**FARR WEST CITY
PLANNING
COMMISSION
AMENDED AGENDA**

FARR WEST SURGICAL CENTER

RE: **FARR WEST SURGICAL CENTER**
Site Plan Review

Our office has completed a review of the site plan for the Farr West Surgical Center located at 1804 West 2550 North. We have reviewed the improvement drawings and recommend approval of this development subject to the following comments:

SITE PLAN

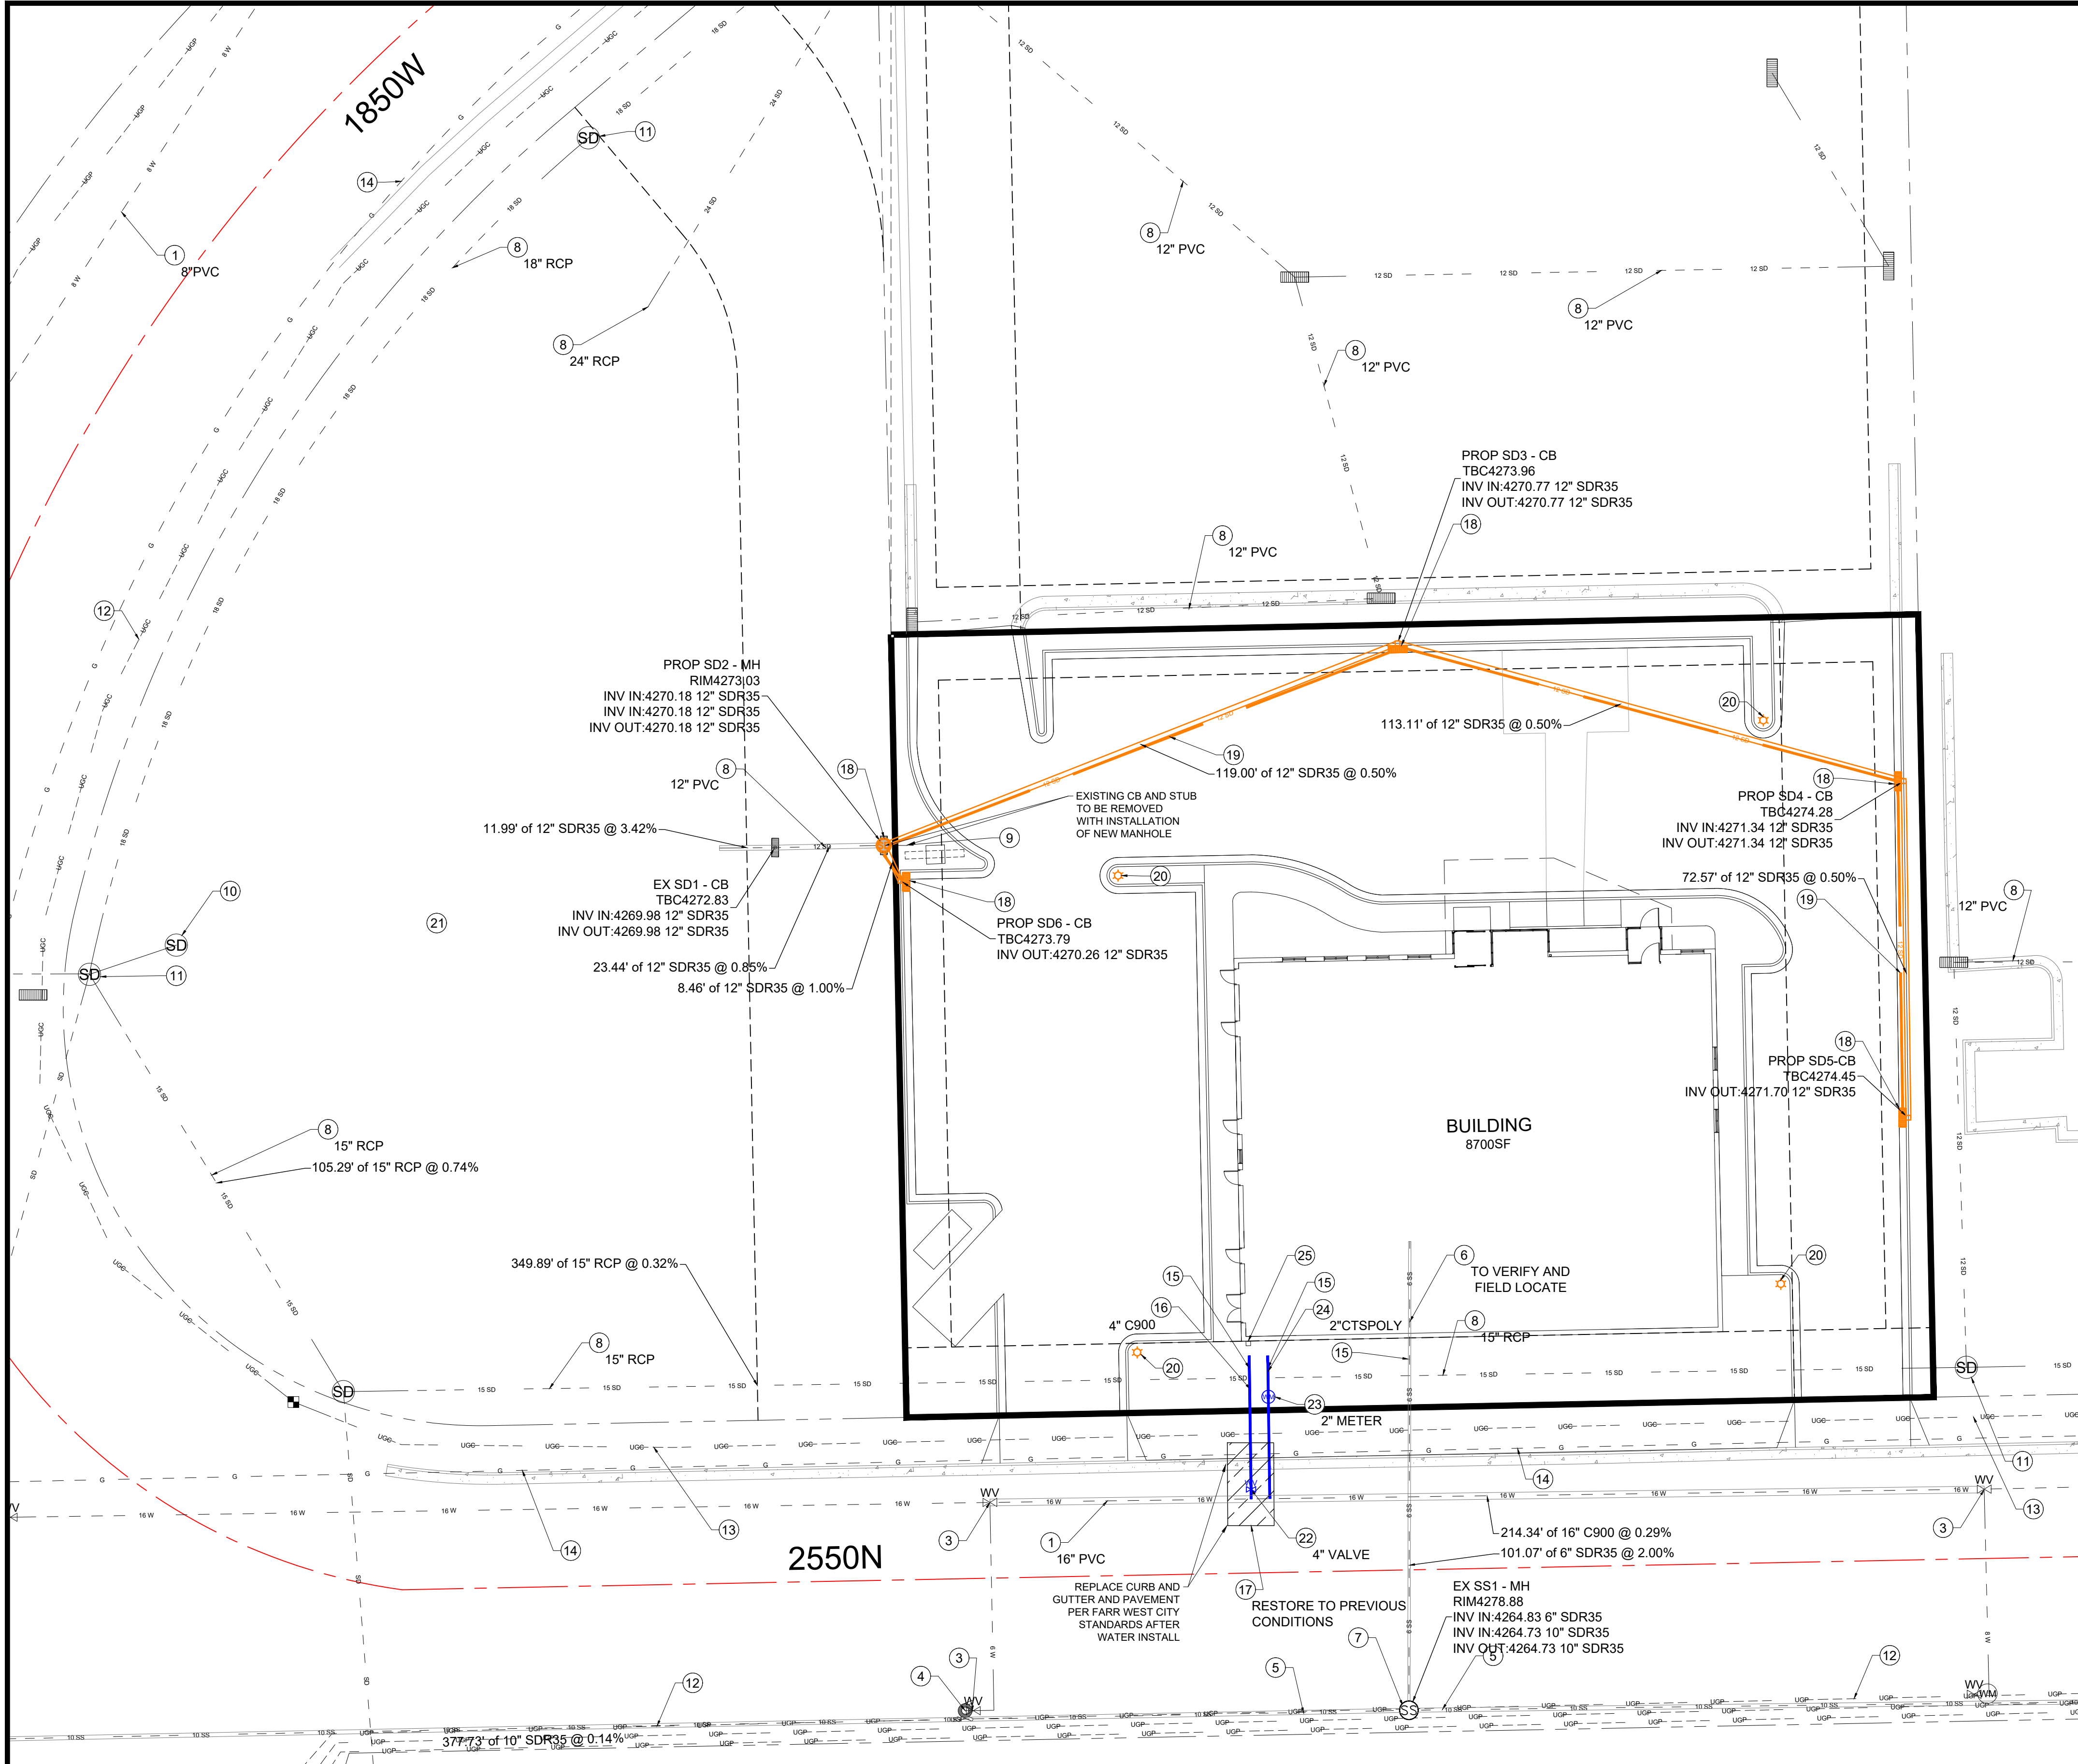
1. Gain approval from the Planning Commission for the number of parking stalls provided. The site provides 38 parking stalls which is short of the 44 stalls required for an office building in the City code. The developer has provided a parking space analysis which projects that 28 stalls would be the maximum that they would need for their business. The provided parking is likely sufficient for their use and the design of the site maximizes the number of stalls but approval should be obtained for this variance.
2. A pre-construction conference with the Developer and their Contractor should be held with the City and utility providers prior to beginning any construction.
